ATTACHMENT

Proposed Technical Specification Changes

UNIT 1

FIGURE 6.2-2 FACILITY ORGANIZATION

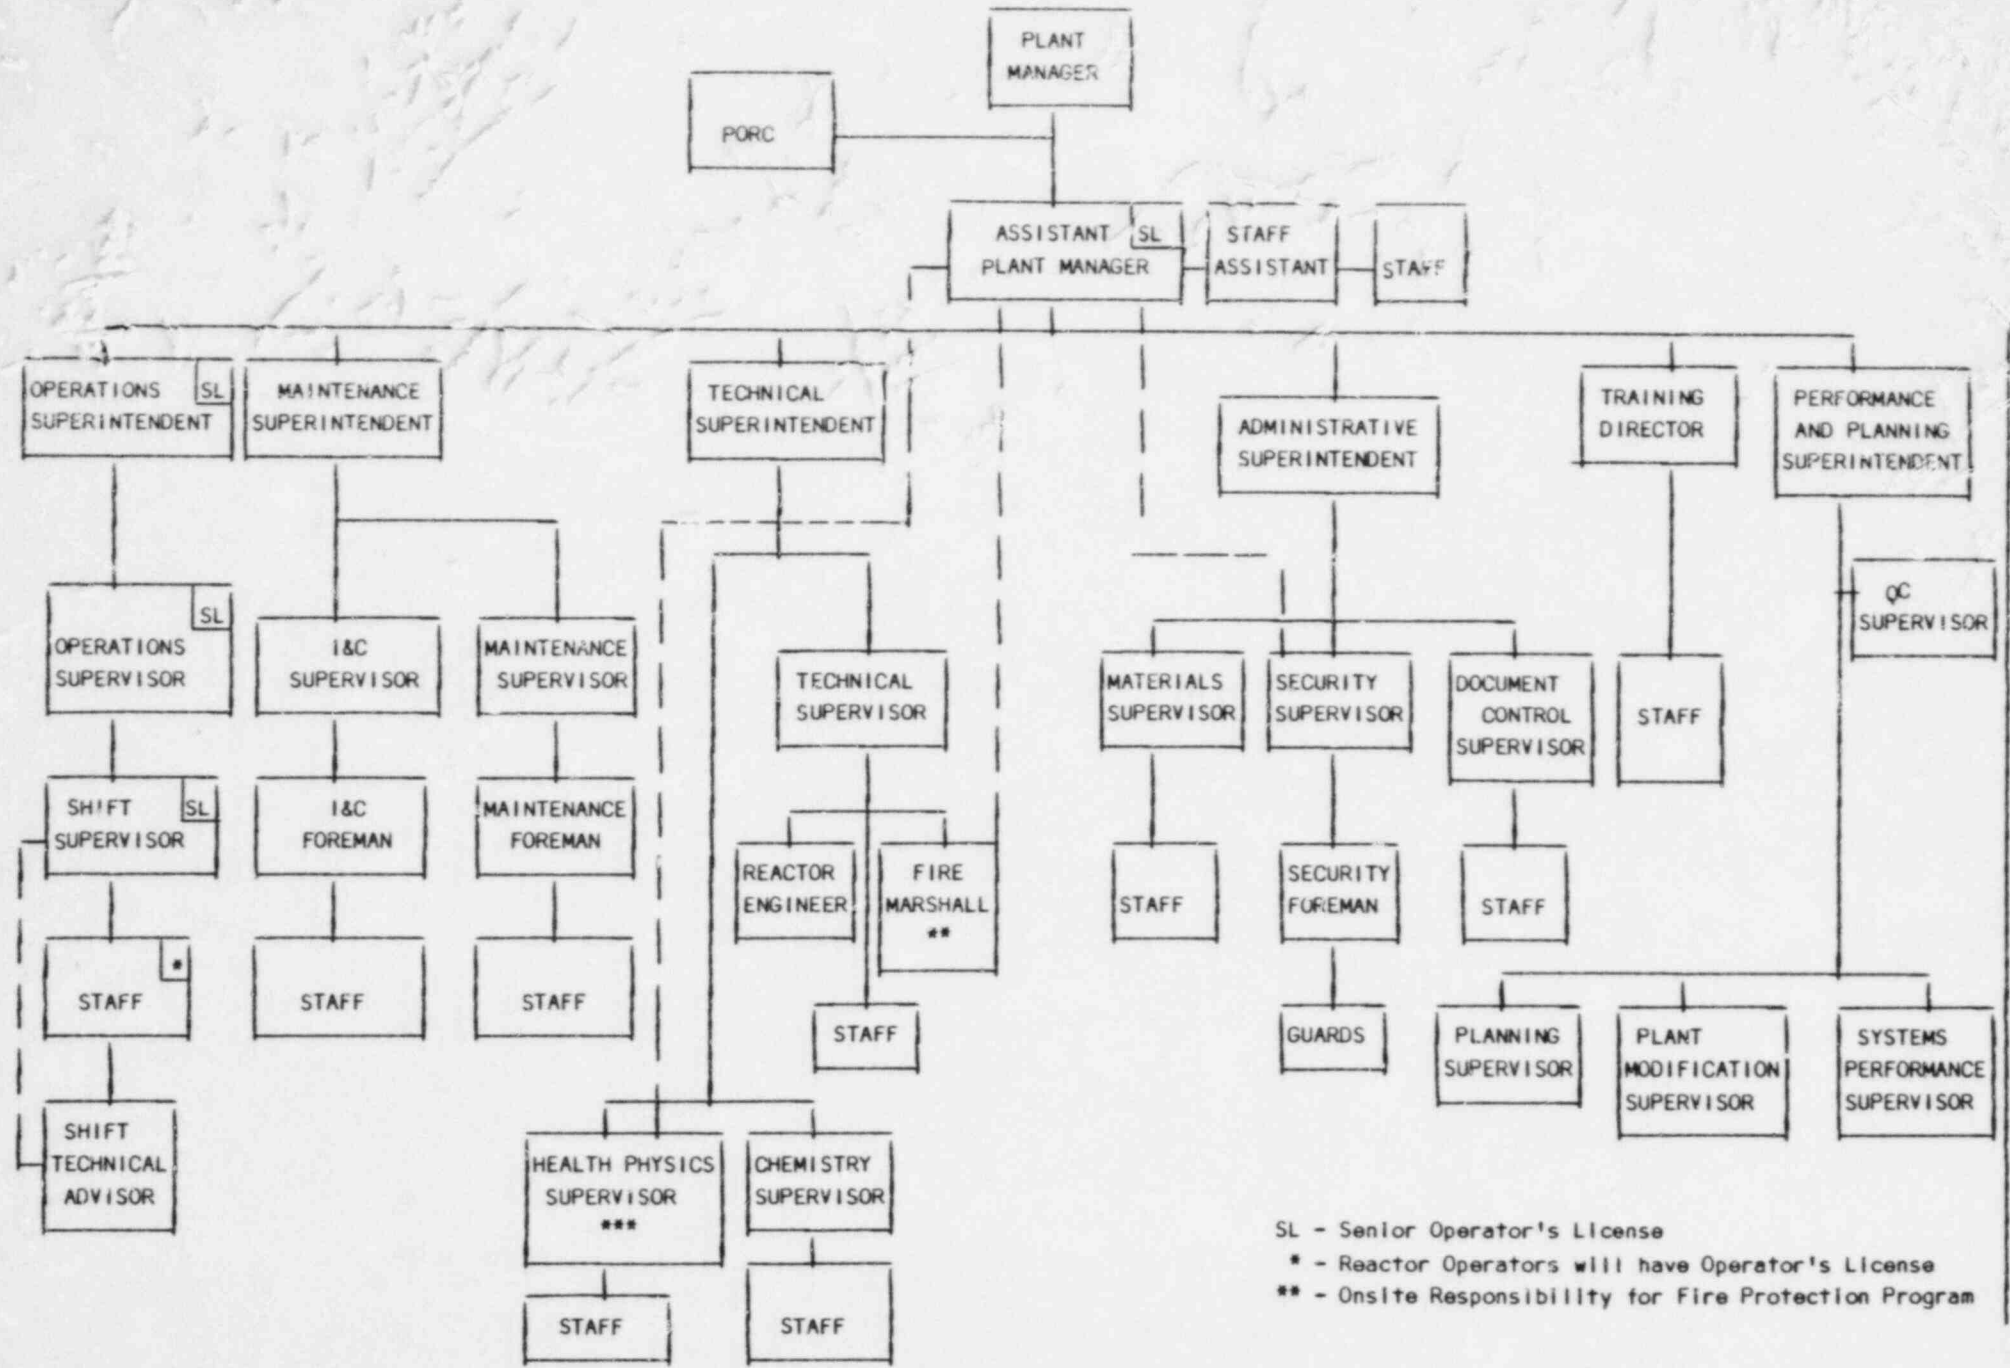
SL - Senior Operator's License
 * - Reactor Operators will have Operator's License
 ** - Onsite Responsibility for Fire Protection Program

*** In routine matters, the Health Physics Supervisor reports directly to the Technical Superintendent, in matters of radiation policy determination, interpretation or implementation (based upon the Health Physics Supervisor's judgement) the Health Physics Supervisor may report directly to the Assistant Plant Manager.

FIGURE 6.2-2 FACILITY ORGANIZATION

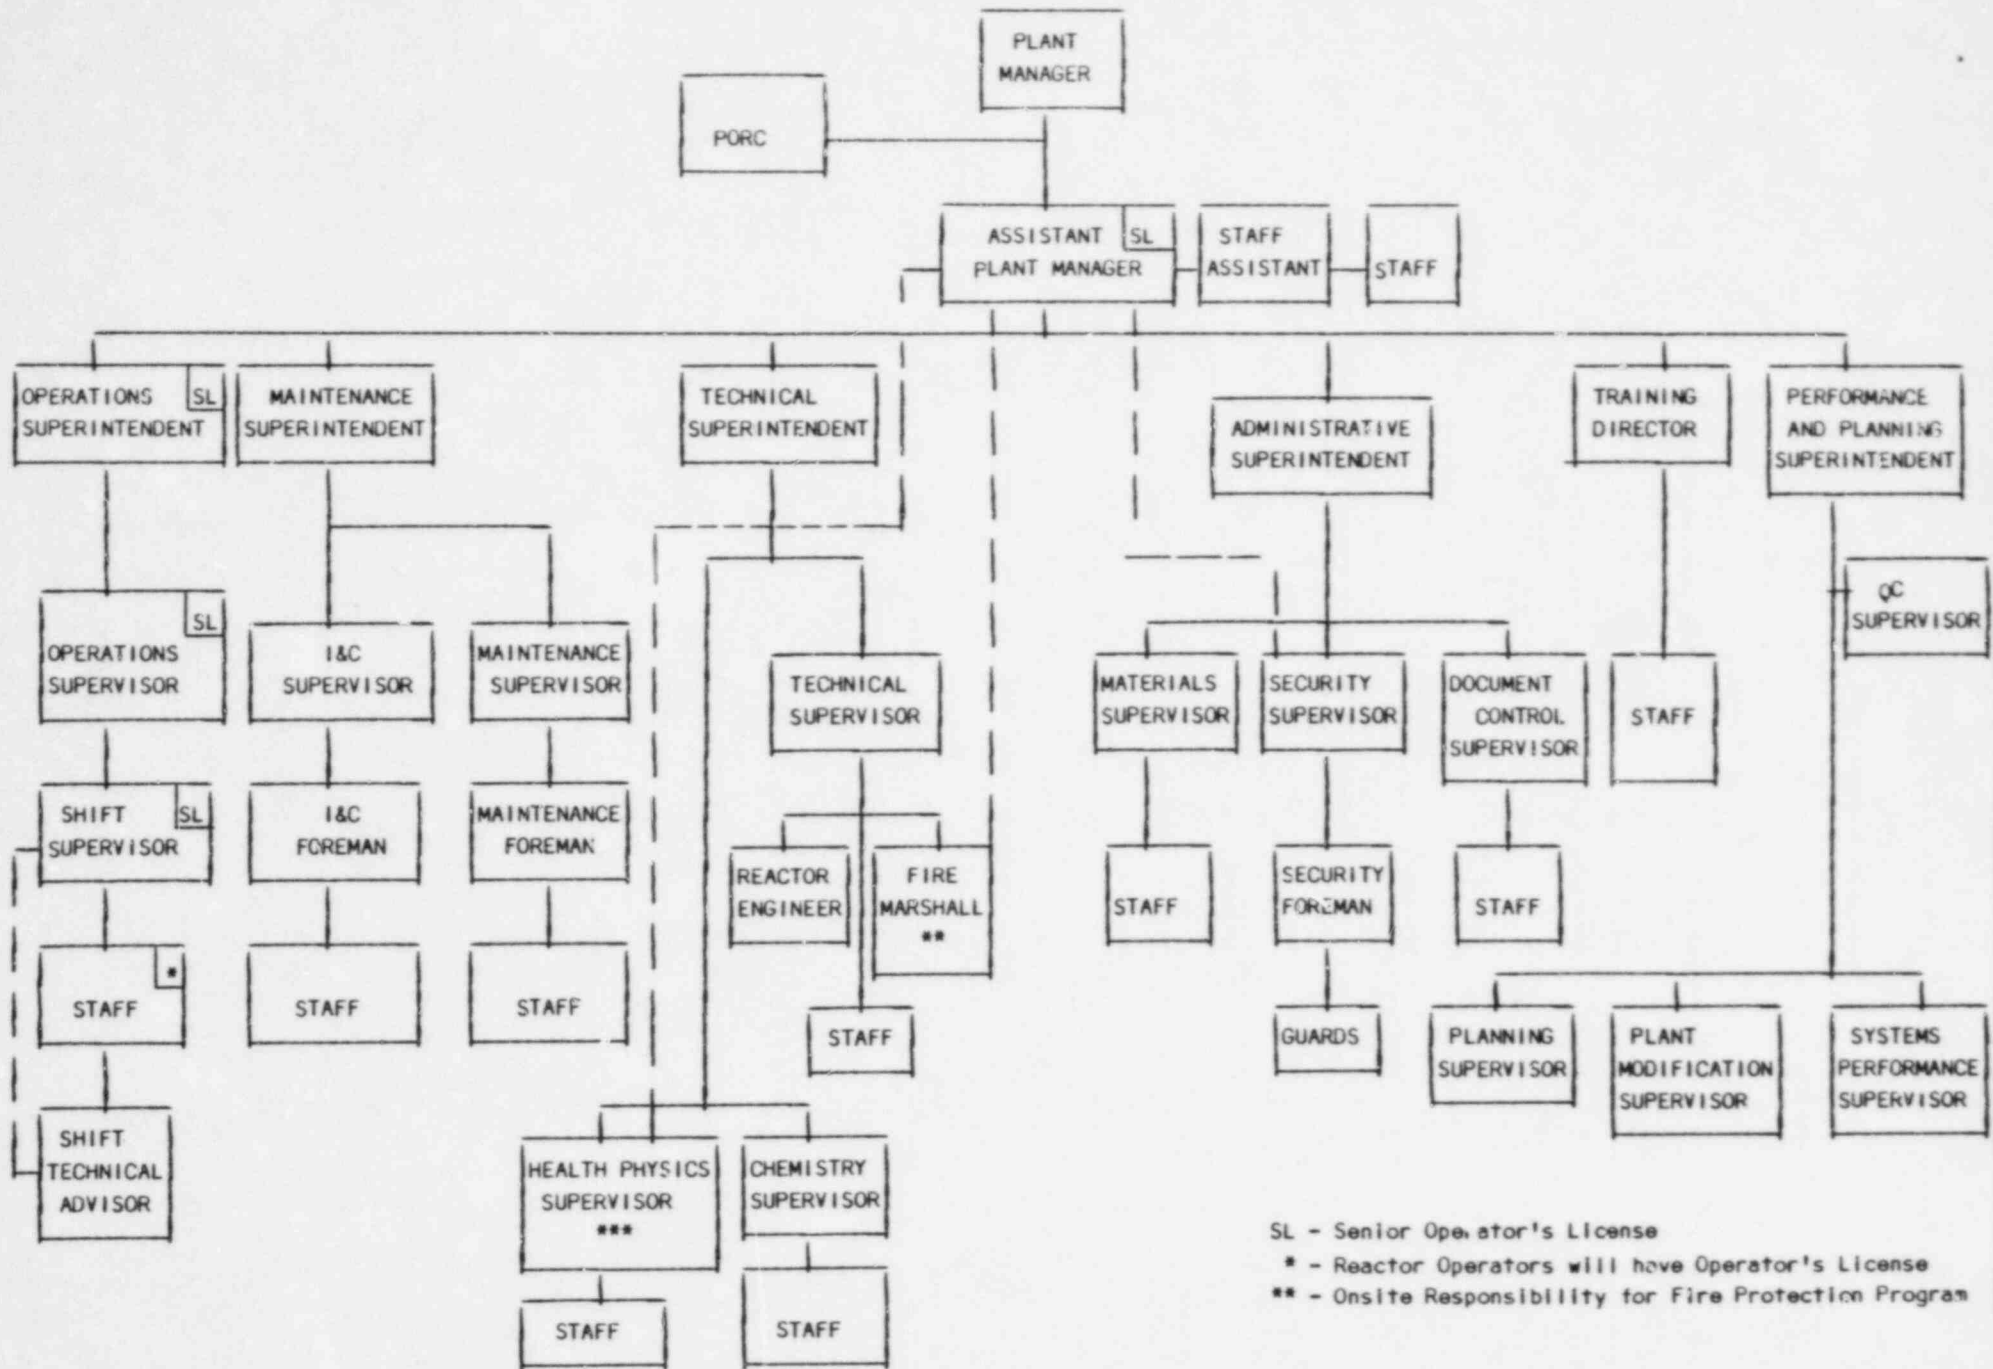
SL - Senior Operator's License
 * - Reactor Operators will have Operator's License
 ** - Onsite Responsibility for Fire Protection Program

*** In routine matters, the Health Physics Supervisor reports directly to the Technical Superintendent, in matters of radiation policy determination, interpretation or implementation (based upon the Health Physics Supervisor's judgement) the Health Physics Supervisor may report directly to the Assistant Plant Manager.
